AMENDMENTS TO THE DRAWINGS

Application No. 10/811,930
Amendment filed October 15, 2007
Reply to Office Action of July 13, 2007

Docket No.: 0465-1787PUS1
Page 17

FIG. 5

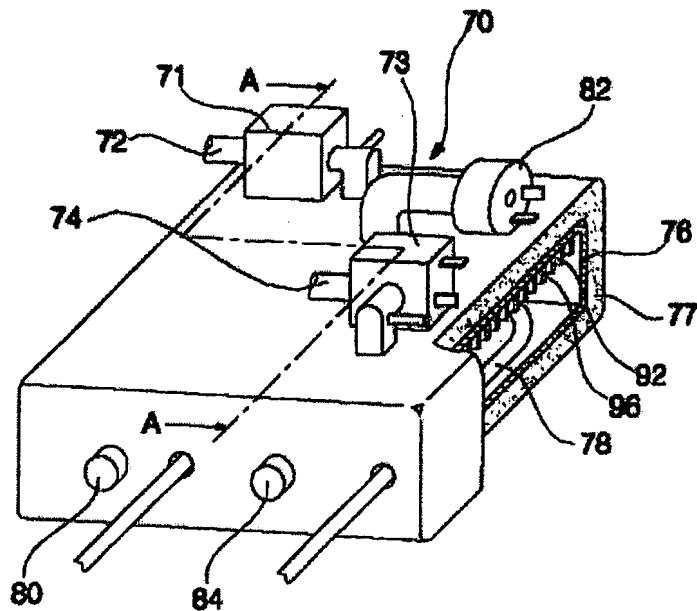
First, the Examiner has objected to the drawings because the reference character 82 of FIG. 4 and reference character 84 of FIG. 5 have been used to designate "an automatic temperature switch." Applicants respectfully submit that this objection is overcome by the amendment of the paragraph beginning on page 16, line 17.

Second, the Examiner has objected to the drawings as they fail to show the correct cross-sectional view taken along line A – A in FIG. 5. Applicants respectfully submit that the drawing change to Fig. 6, where the reference numerals 71 and 73 have been switched, overcomes this objection.

Third, the Examiner has objected to the drawings as they fail to show the reference characters "line B – B in FIG. 5." Applicants respectfully submit that this objection is overcome by the amendment to two paragraphs of the specification, the paragraph beginning on page 9, line 6, and the paragraph beginning on page 9, line 21.

FIG. 6

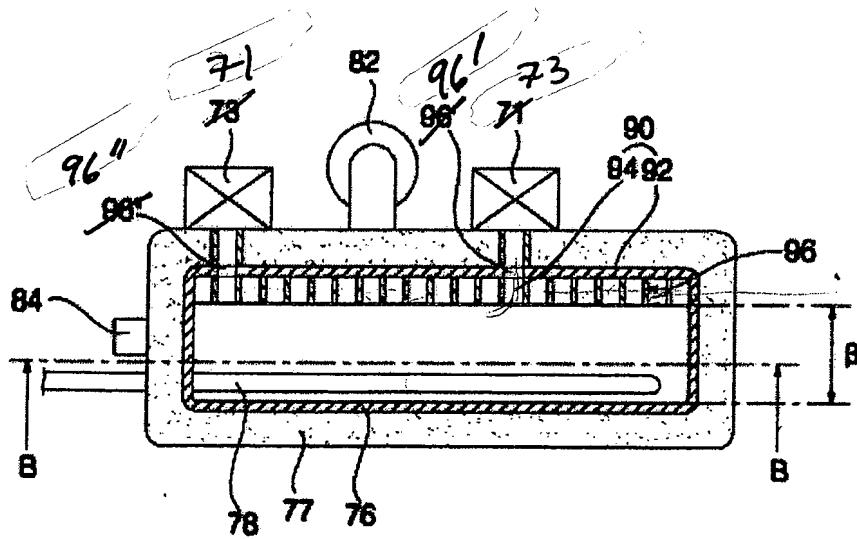
In FIG. 6, reference numerals 96' and 96'' have been redrawn to be more legible, and reference numerals 71 and 73 have been reversed.

Fourth, the Examiner has objected to FIG. 7 as representing different descriptive features when compared to FIG. 5. Applicants respectfully submit that the changes to FIGS. 6 and 7,

makes clear that the orientation of the holes in FIG. 7 is correct. Therefore, this objection is overcome.
